SAN		TITLE: SN3308 SERVICE				
DRAWN BY	CHECKED BY	ENGINEER	APEROVED	DRAWING NUMBER		
K-he			- YD	SB3308-02		
DATE	DATE	DATE	DATE	COMPUTER CONTROLLED		
8/4/00			8.4.00	DRAWING DO NOT REVISE MANUALLY

## SERVICE BULLETIN SB 3308-02

**Explanation:** Regulator failures have been reported after installation of replacement lamp at normal replacement interval using Lamp Kit SPN 90122. Failure is related to stamped code on component L4.

LOCATION OF COMPONENT L4

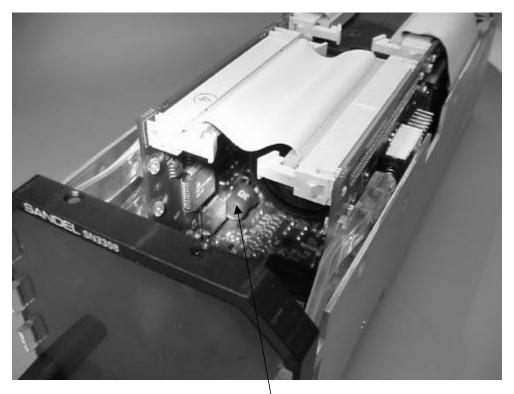
2.	Refer to attached photograph for position of affected component (L4).			
	3.	This component will be stamped "100" or "3R3". Visually confirm the stamped code. A partial identification (i.e. using one or more of the 3 characters) is acceptable if the stamped code is not fully in view.

4.	If the stamped code is determined to be "3R3", perform the balance of the normal lamp replacement (if required) and return the unit to service.			
	5.	If the stamped code contains a "1" or "0" <u>or</u> the code cannot be verified, the unit must be <b>returned</b> to Sandel for repair.			
Testing:		Perform normal ground checkout procedures on the SN3308 after re-installation per Sandel SN3308 installation manual 90106-IM, applicable revision.
